ADDENDUM NO. 2

Reference: Woodbury Business Building Remodel
Utah Valley University – Orem, Utah
DFCM Project No. 09171790

ADDENDUM #02 to the “Construction Documents”

Addendum #02

PROJECT NO: 09031
DATE: 2/16/10
SHEET: AR5-01

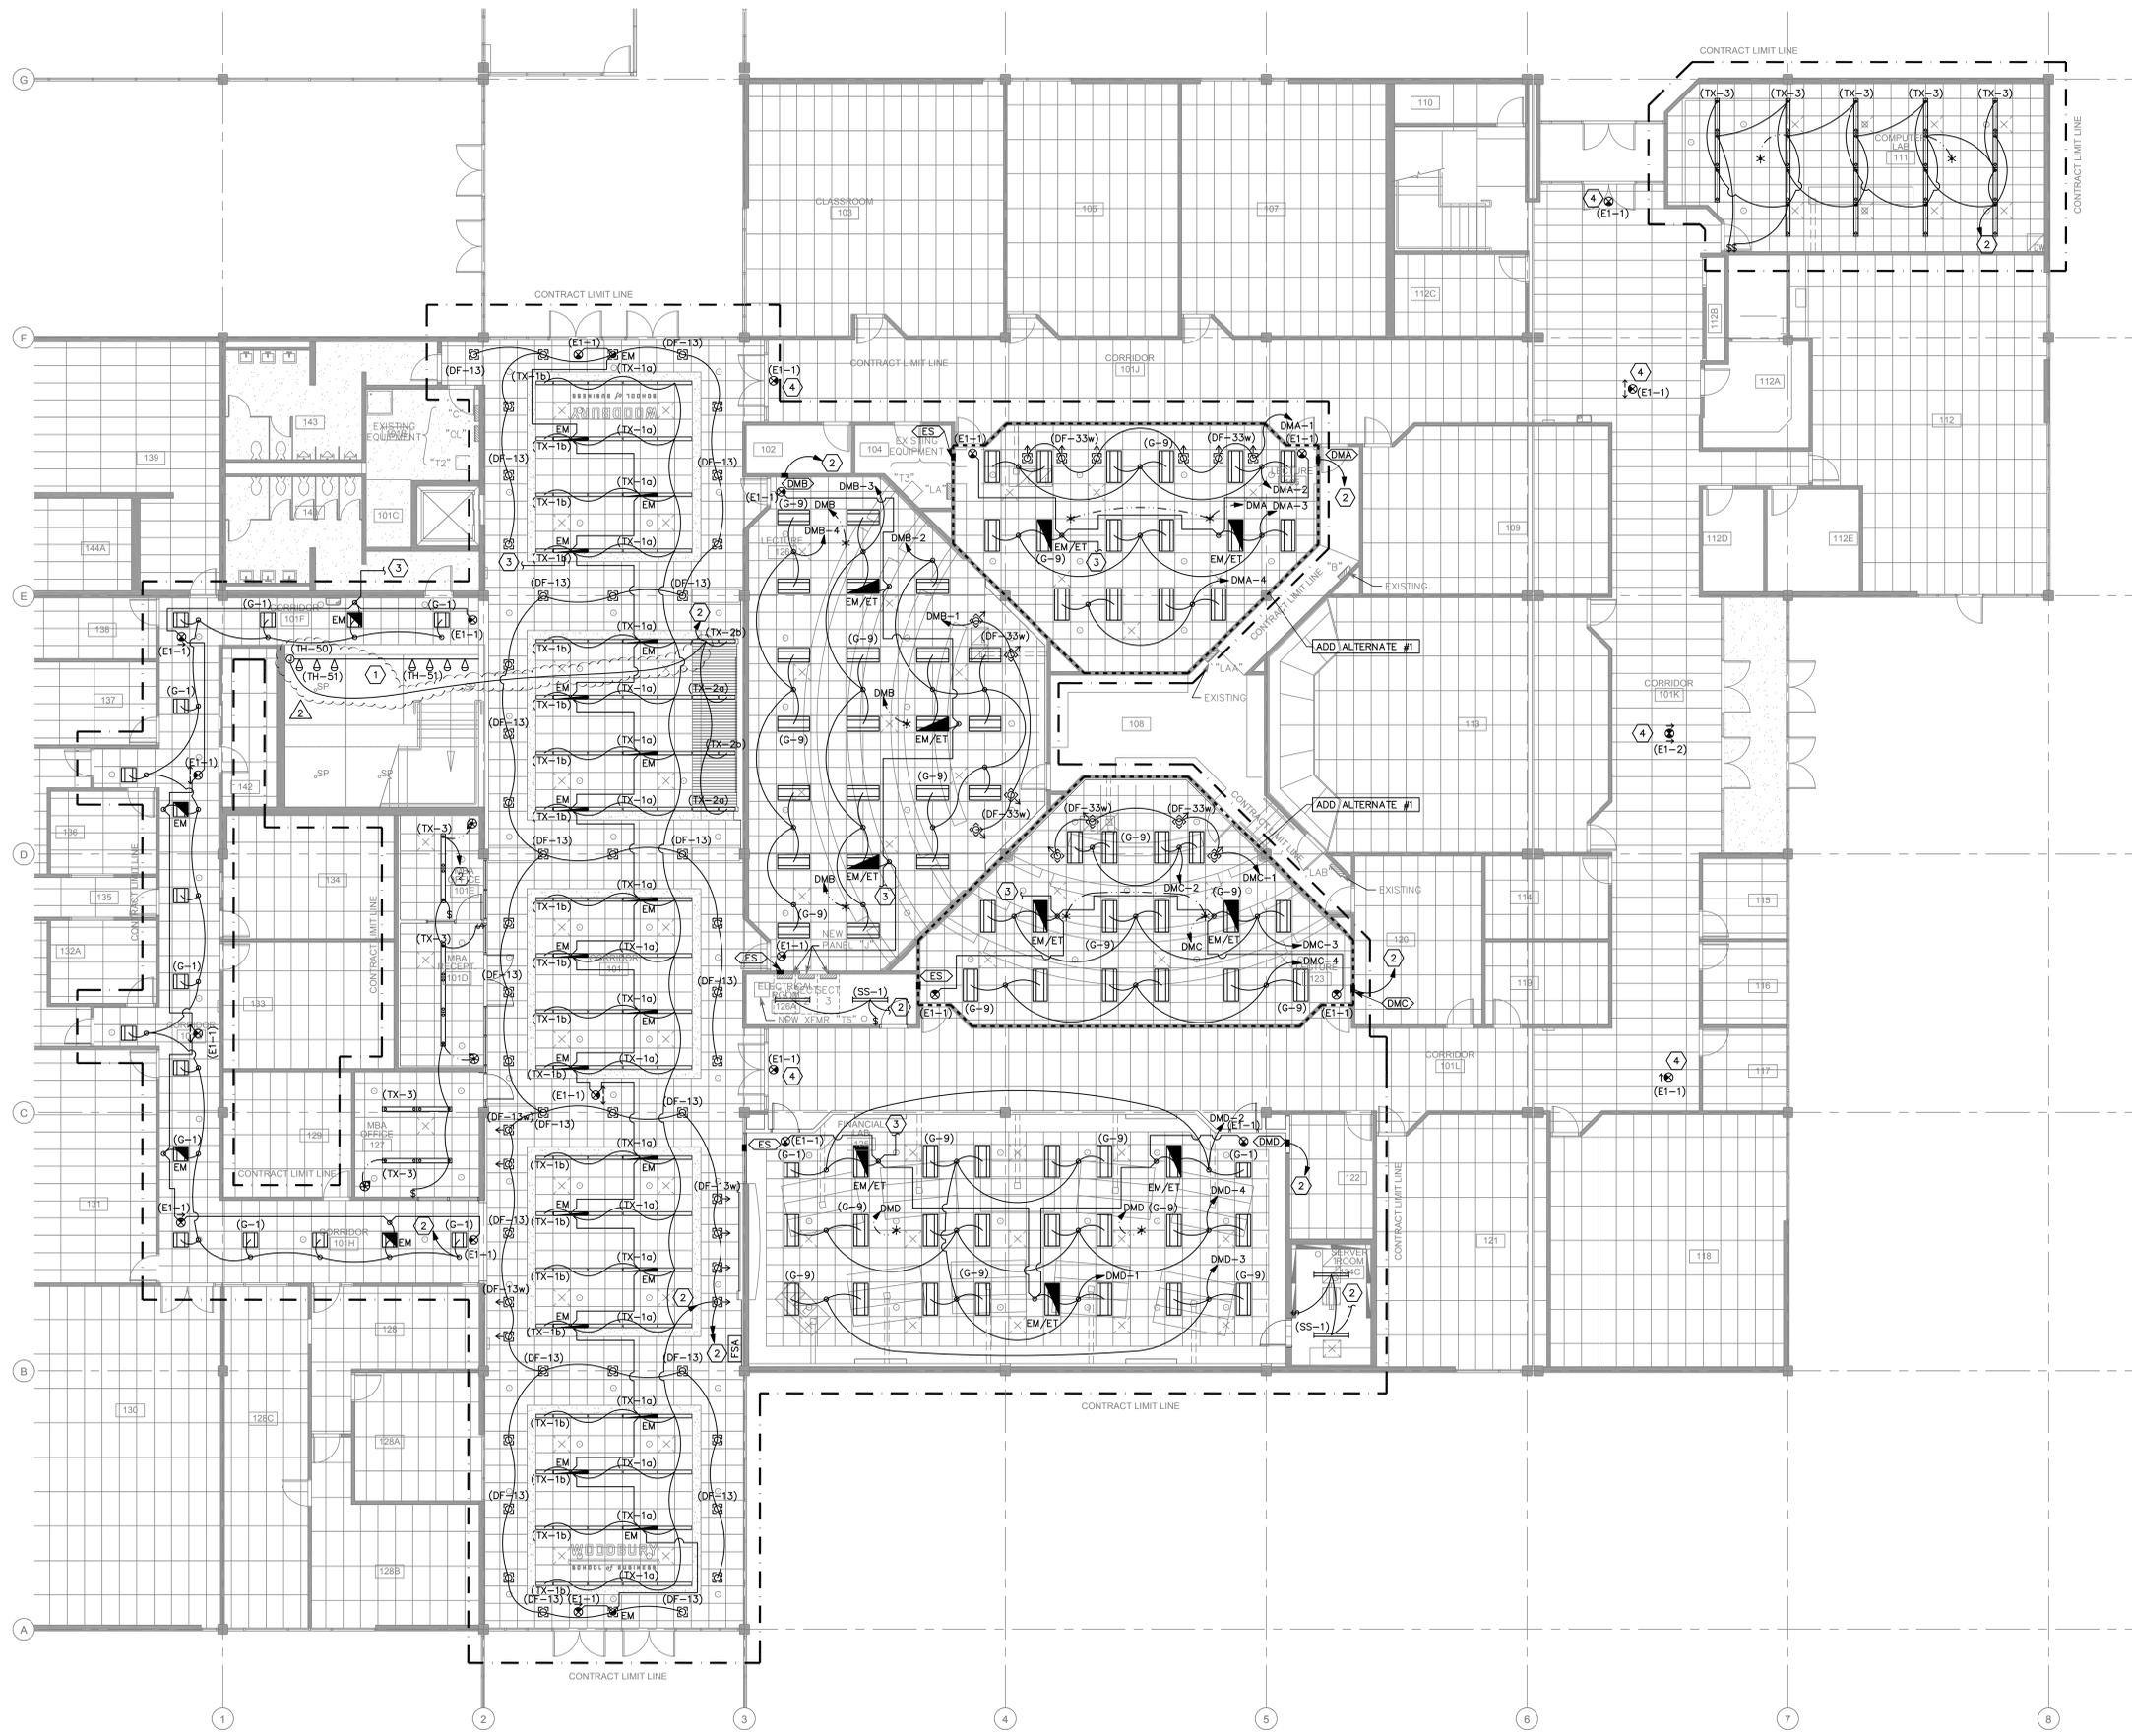
- 02.01 **Change:** The date of Substantial Completion to Wednesday, August 18, 2010.
- 02.02 **Prior Approval Request:** Add Aquatherm Pipe to List of Manufacturers.
Response: Aquatherm Pipe will not be added to the list of manufacturers. There is no domestic water, heating or cooling water piping required for this project. The only piping required for this project is fire protection piping and the Aquatherm piping is not acceptable for fire sprinkler piping systems.
- 02.03 **Clarification:** AV equipment purchase and install is not to be included in the bid, see general note #19 on sheet AG0-01. Notes pertaining to AV equipment on architectural sheets AE5-11, AI2-01, AI2-02, and AR5-01 have been modified to clarify this scope.

A1 LEVEL ONE LIGHTING PLAN
SCALE: 1/8" = 1'-0"

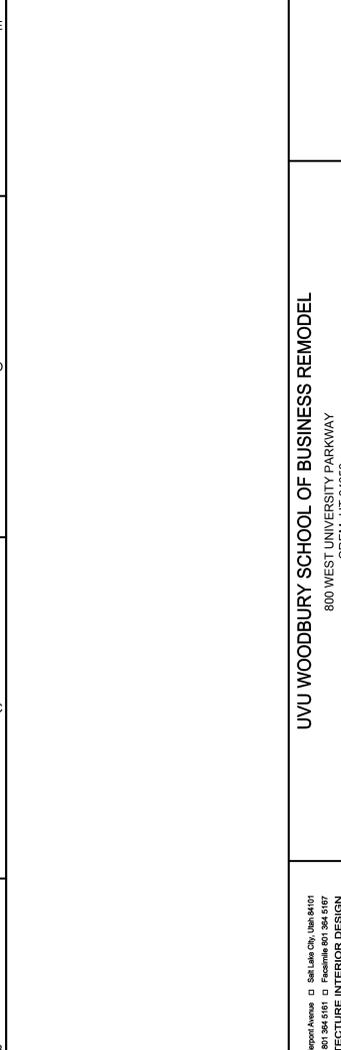
SHEET - EL101

1. Circuit (TH-50) track with (TX-2a) and (TX-2b) fixtures.

D2 FINANCIAL LAB 125 LIGHTING CONTROL SCHEMATIC
NO SCALE

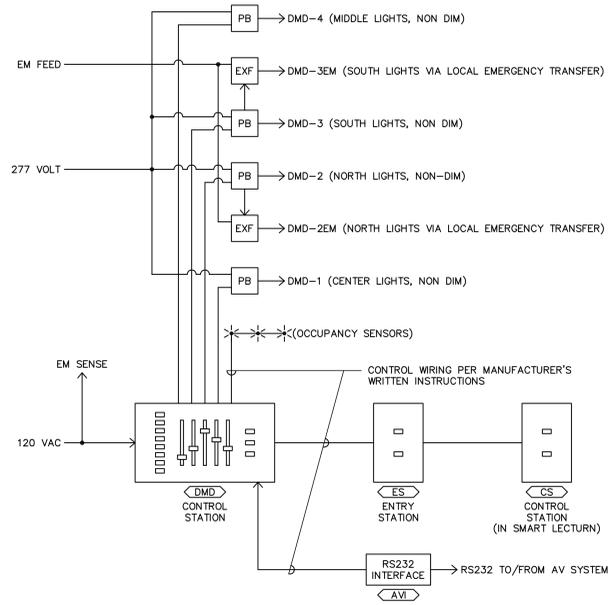
SHEET - EL601

1. Detail D2: Rename to "Financial Lab 125 Lighting Control Schematic."

03/29/10 ADD #01
04/19/10 ADD #02
PROJECT NO: 09031
DATE: 2/16/10
SHEET: EL6-02

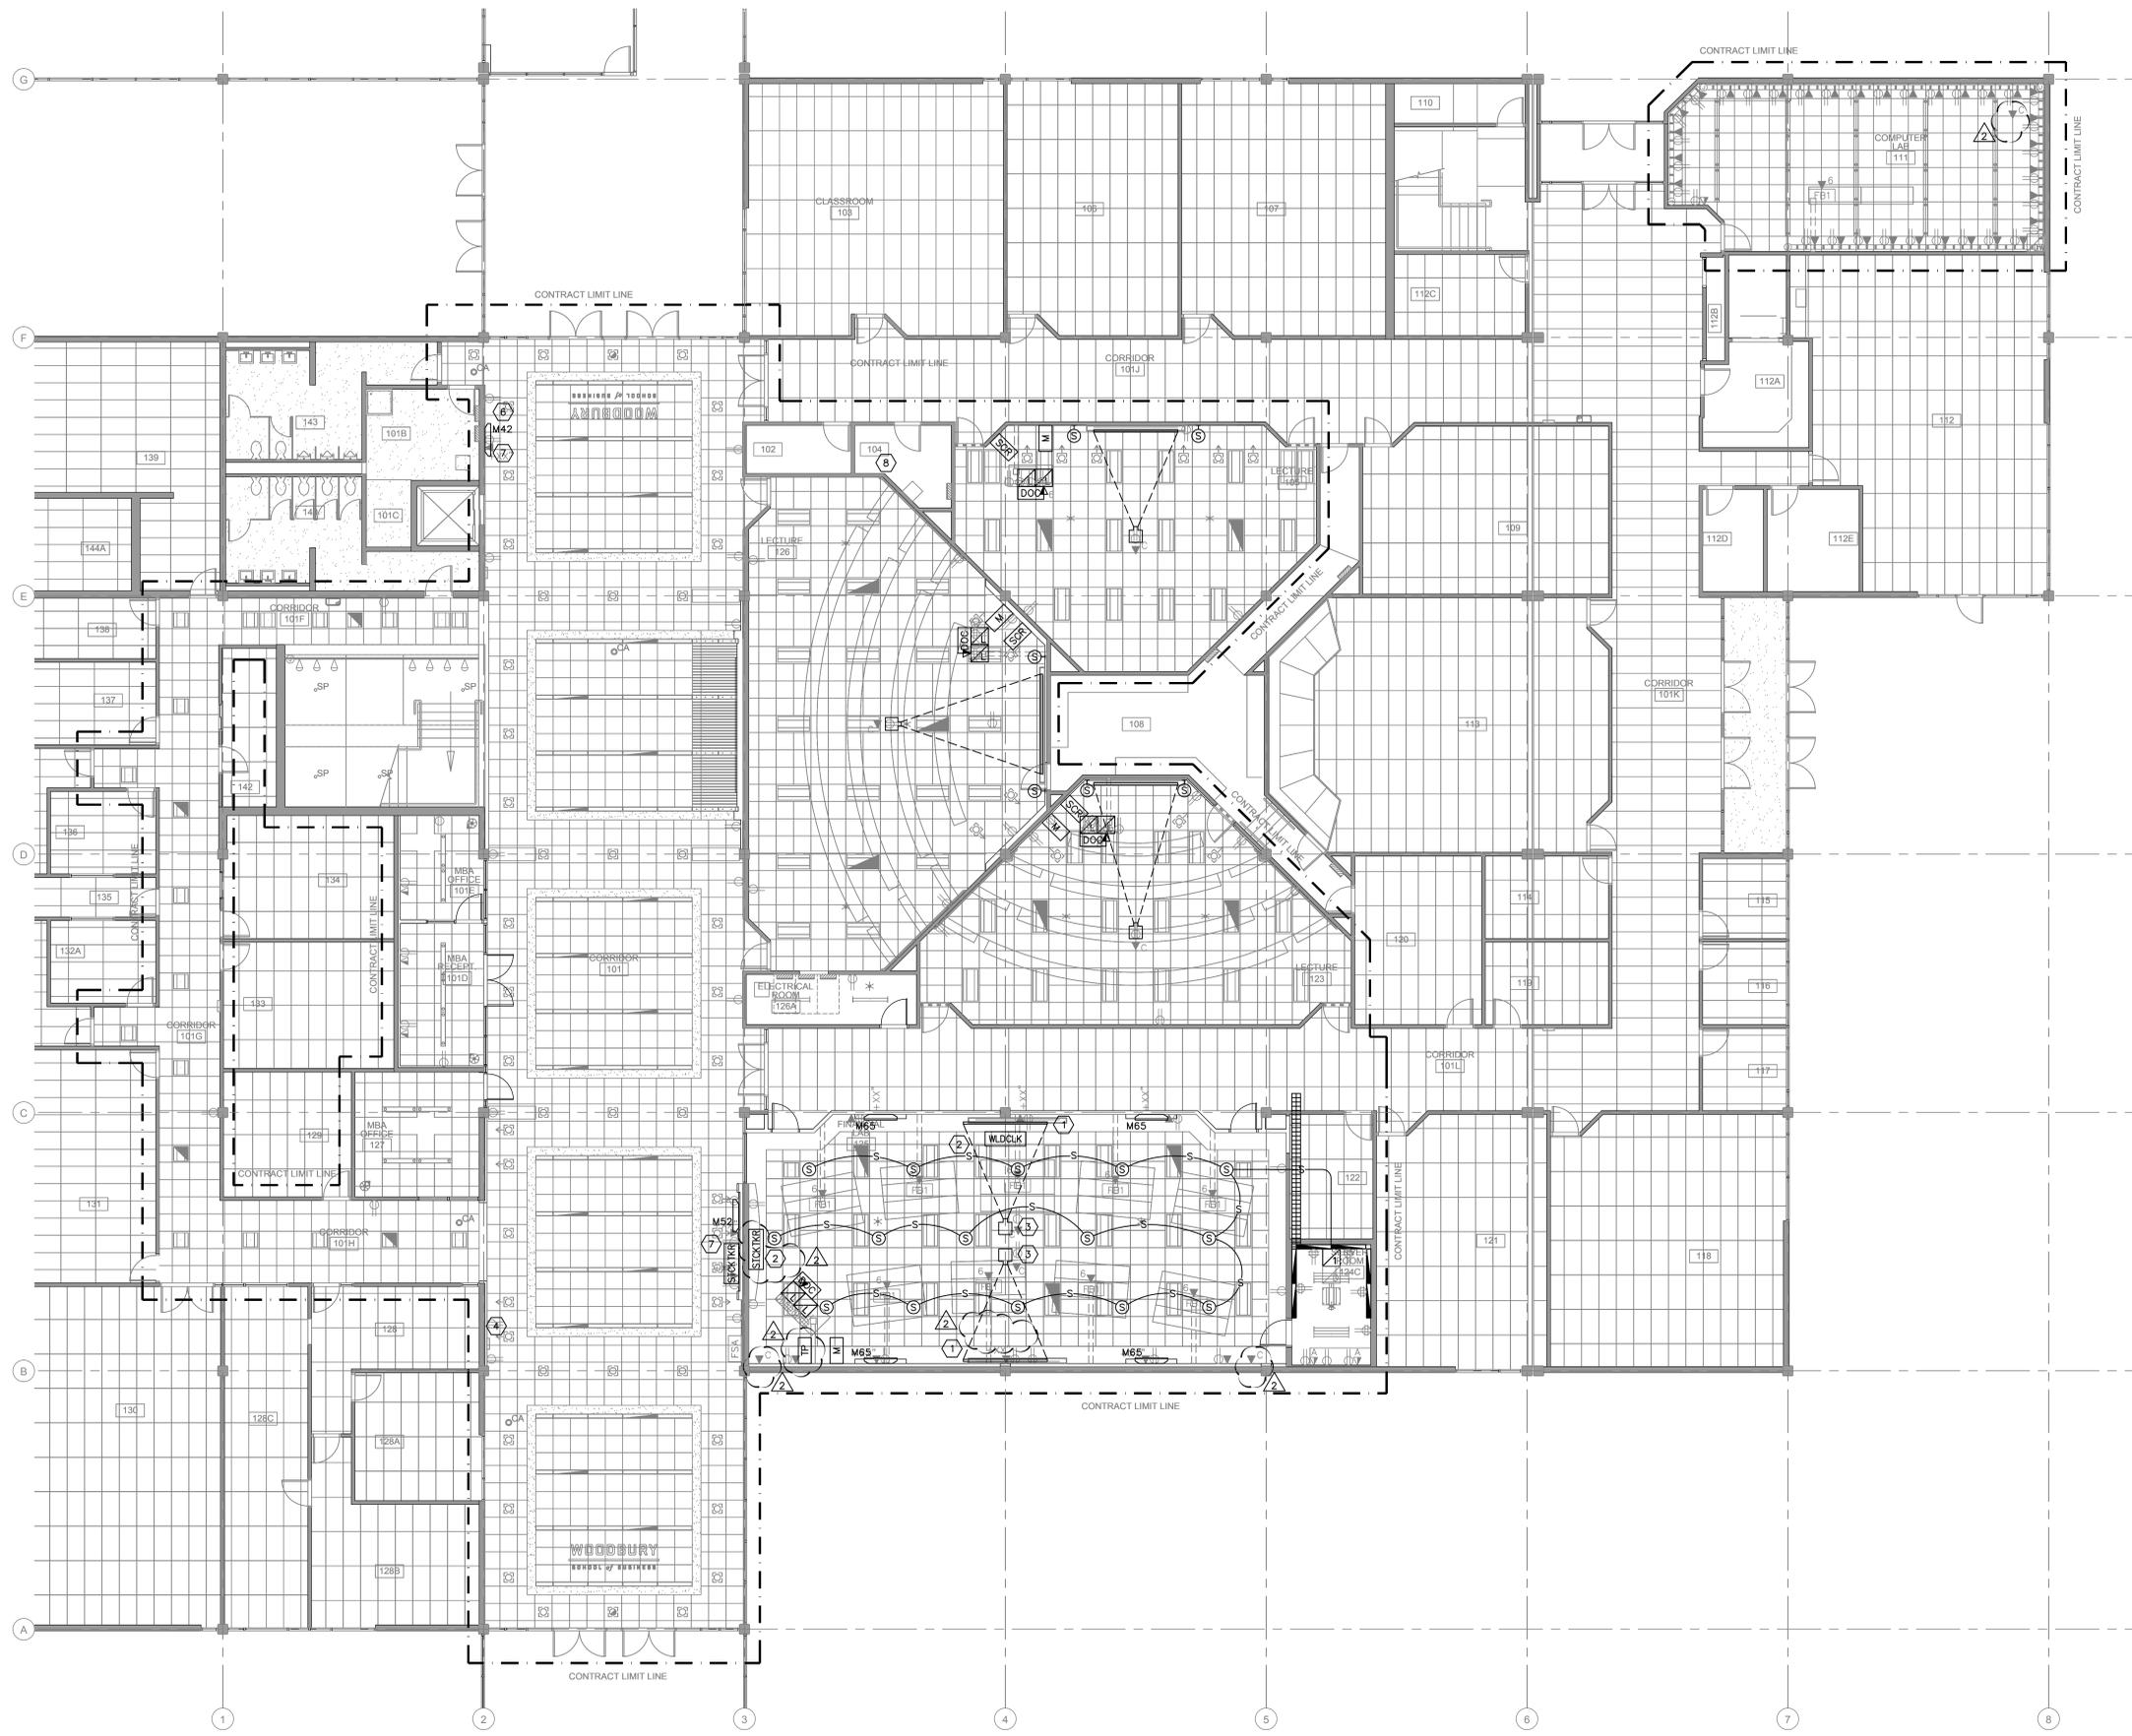
SHEET - EL602

1. TH-51: Change voltage to 120V.
2. TX-2a: Change length to 3', lamps to 3-MR16 and Watts to 150W.
3. Add dimming schedules for DMA, DMB, DMC and DMD. See sheet for details.

REVISIONS:	PROJECT NO:
03/29/10 ADD #01	09031
04/19/10 ADD #02	DATE:
	2/16/10
	SHEET:
	EJ6-01

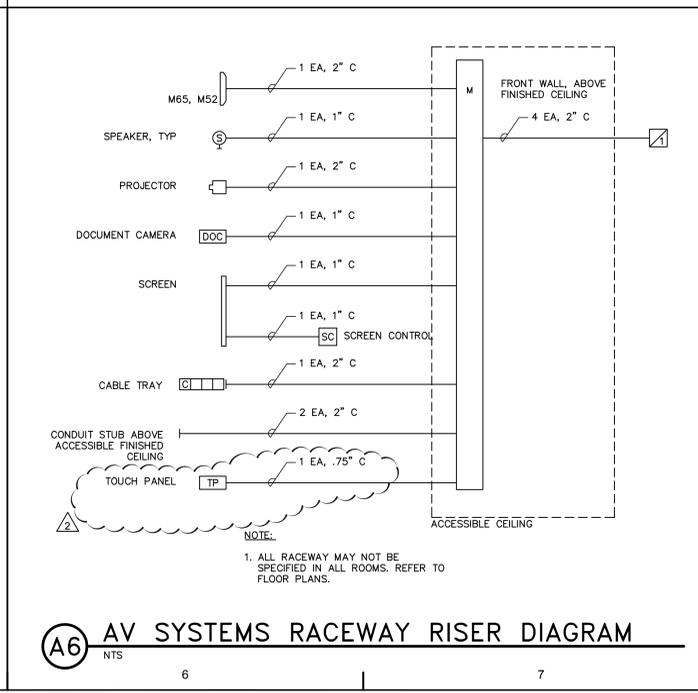
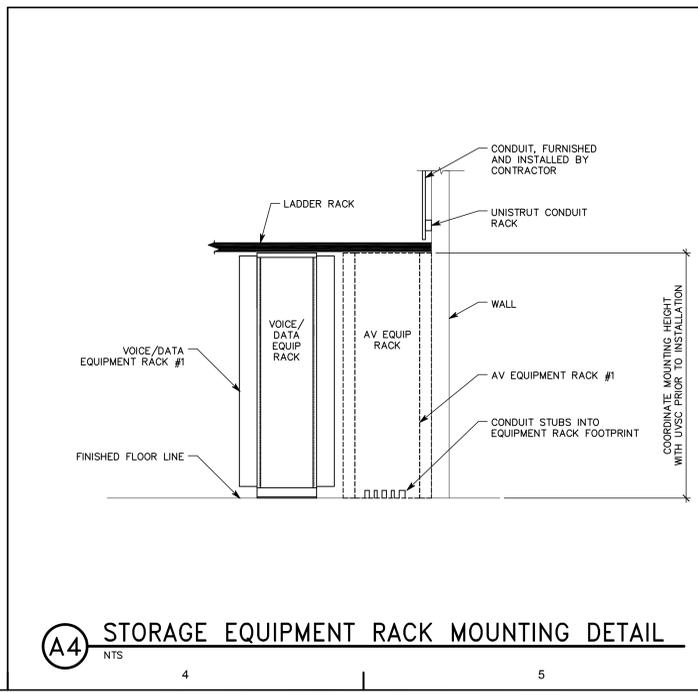
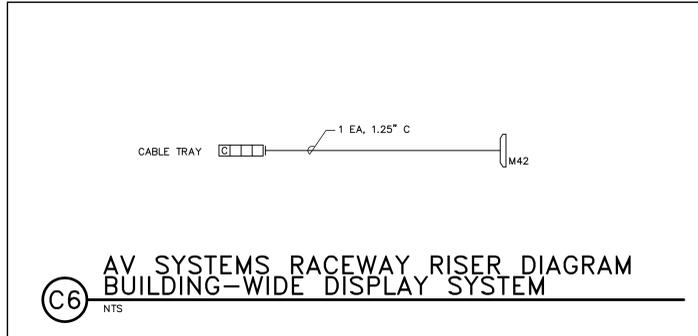
SHEET - EJ601

1. The rough-in box for 'TP' will be furnished by the AV installer and installed by the electrical installer. Provide a 1" conduit from TP to the accessible ceiling. Mount at electrical switch height.
2. The AV systems indicated on the TA sheets are to be provided by the owner. The Rough-in and for the AV systems as indicated on the EJ sheets is to be provided by the electrical installer. Coordinate all rough-in for AV systems with UVU Media Services personnel.

REVISIONS:	03/29/10 ADD #01
	04/19/10 ADD #02
PROJECT NO.:	09031
DATE:	2/16/10
AV SINGLE LINE DIAGRAMS	SHEET:
SCALE: AS NOTED	TA6-01

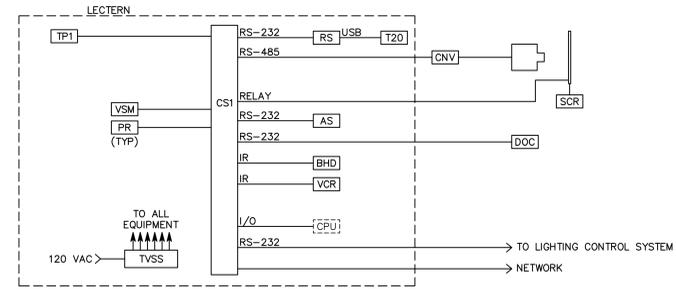
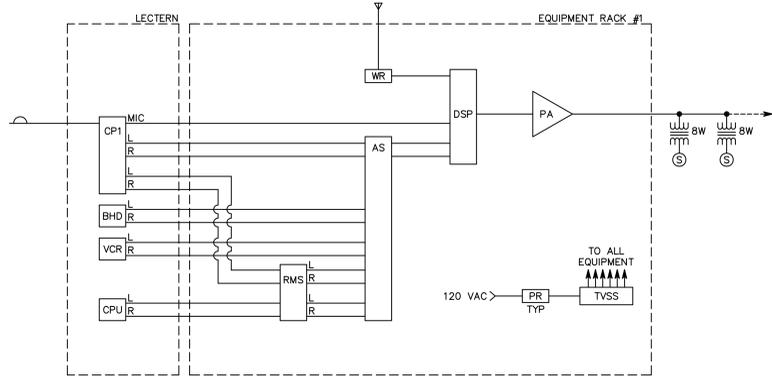
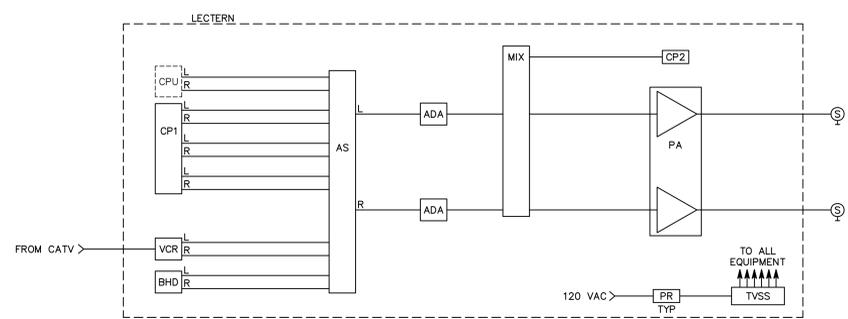
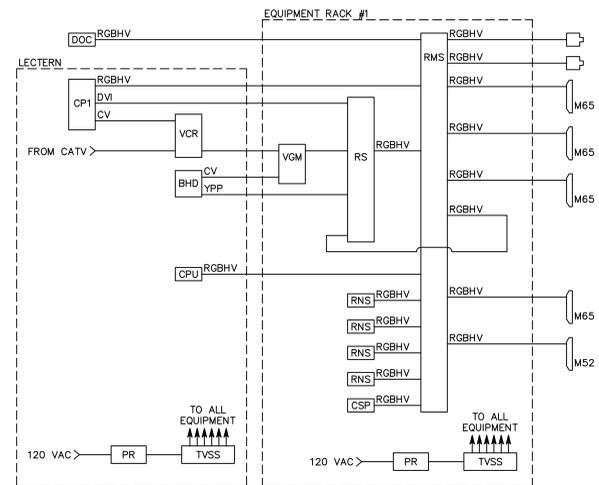
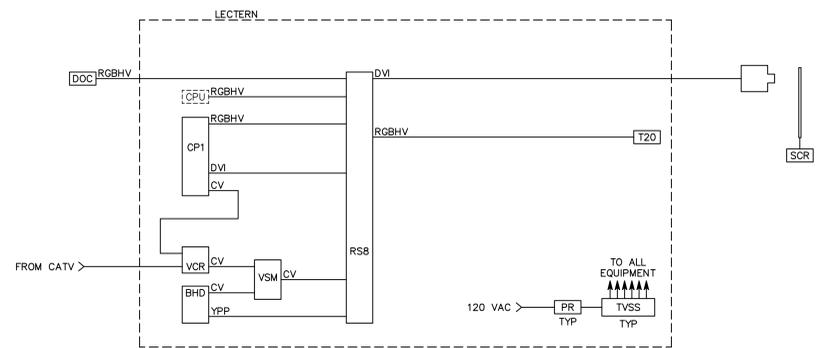
SHEET - TA0-01, TA5-01, TA6-01

1. All AV for this project will be provided by UVU personnel. AV system are not to be installed under the general contract. TA sheets are included for coordination purposes only.
